Panoramic roof roller sun blind rubs on headliner and can be irreparably damaged

Topic number	LI77.21-P-060553
Version	2
Design group	77.21 Panoramic roof
Date	06-26-2015
Validity	Model series 217 up to VIN end no. 008167
Reason for change	VIN range revised
Reason for block

Bild 1.JPG:

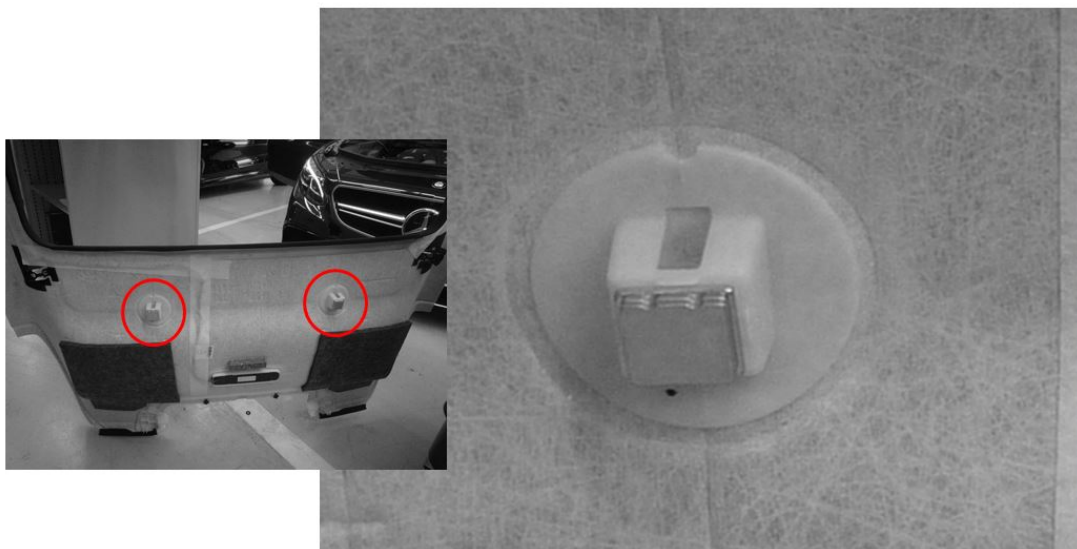
- Remove headliner.
- Attach two additional retainers (magnetic) per side on the two domes, see Figure 1.

Bild 2.jpg:

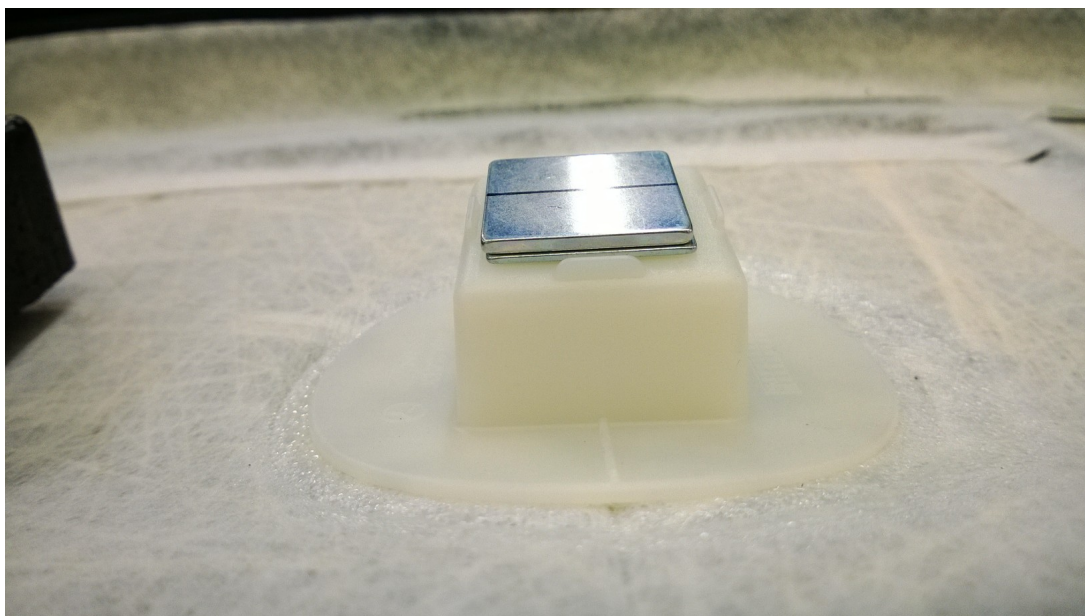
Note: One retainer is already mounted on a carrier plate, see Figure 2.
